P-6001-A Paragon Senior Control Assembly

Installation, Operation, and Maintenance

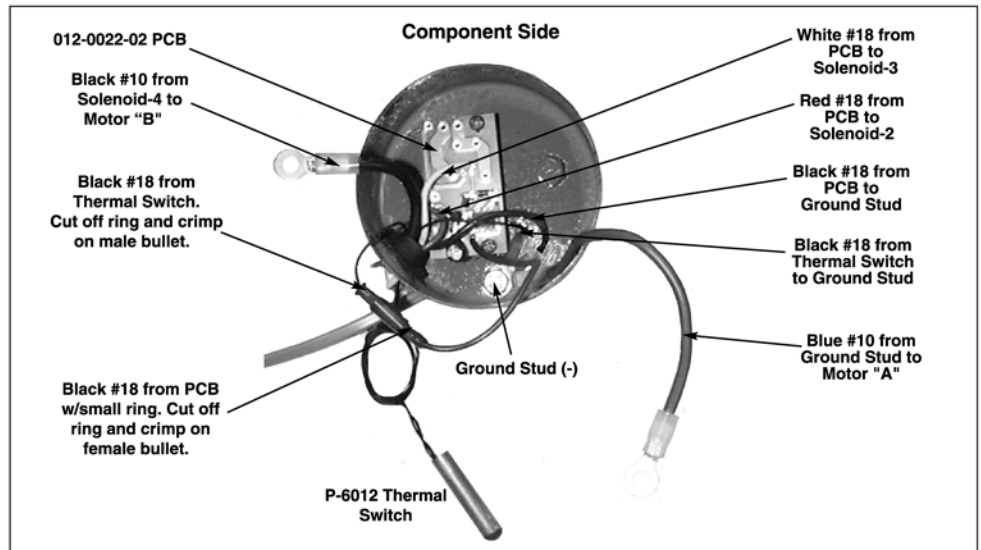
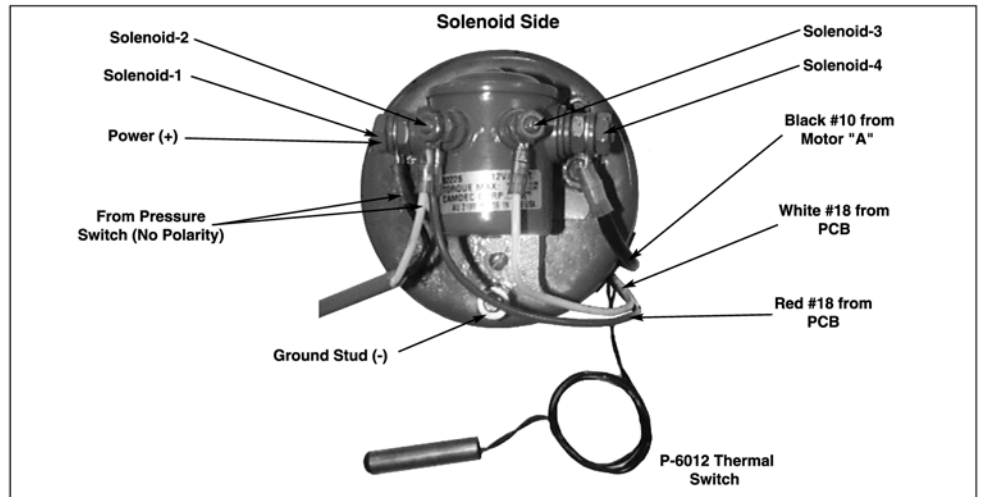
P-6002 (PCB with Thermal Switch) is no longer available; it is replaced by 012-0022-02 PCB, and P-6012 Thermal Switch, sold separately.

012-0022-02 is supplied with ring terminals for use with pumps manufactured after 3/00. Mounting and function are the same, but note that 012-0022-02 and P-6012 Thermal Switch are both connected to the ground stud.

If in your installation you wish to utilize the old Thermal Switch, you must cut the ring terminals off the new PCB and crimp on bullet terminals as instructed and pictured below.

Ensure that the ground stud is properly assembled. The two isolation washers must prevent electrical contact between any connected wire and the metal motor cap.
